Subject: HARD TO SHIFT INTO 3RD GEAR	Bulletin No: 05-008/14
	Last Issued: 07/14/2014

2012-2013 Mazda3 (SKYACTIV 6 M/T)

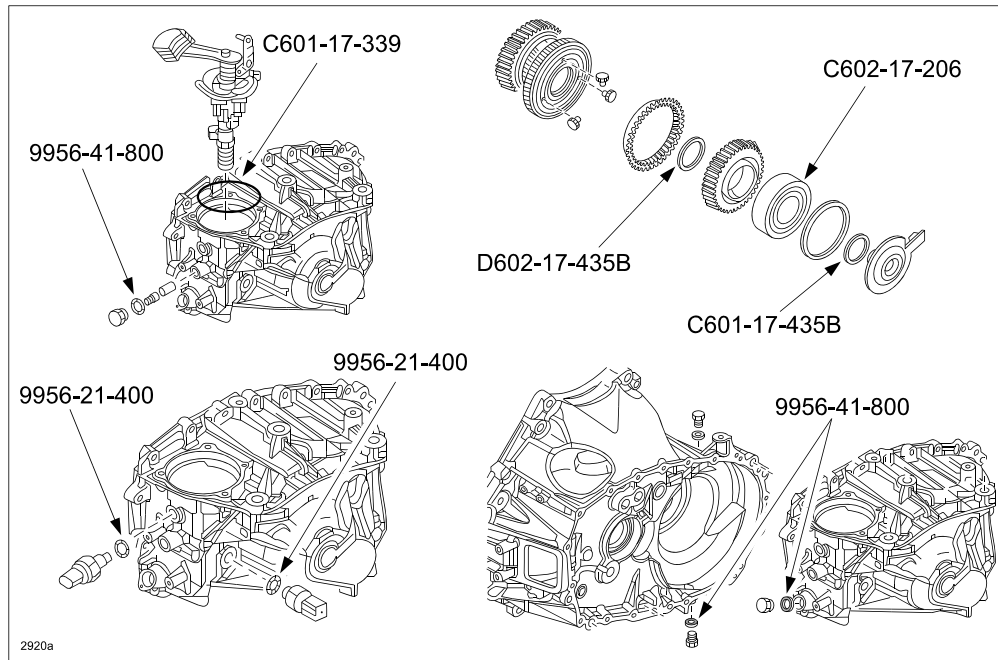
This is caused by the friction coefficient between the 3/4 clutch hub and the sleeve increasing. A surface treatment has now been added to the 3/4 clutch hub to decrease the friction coefficient.

1. Verify customer concern.
2. Remove the transaxle. Refer to MS3 online instructions or the Workshop Manual section 05-15.
3. Replace the 3/4 clutch hub with a modified one and the 3rd gear with a new one (listed in the Parts Information). Refer to the C66M-R 6-speed SKYACTIV Manual Transaxle Workshop Manual.
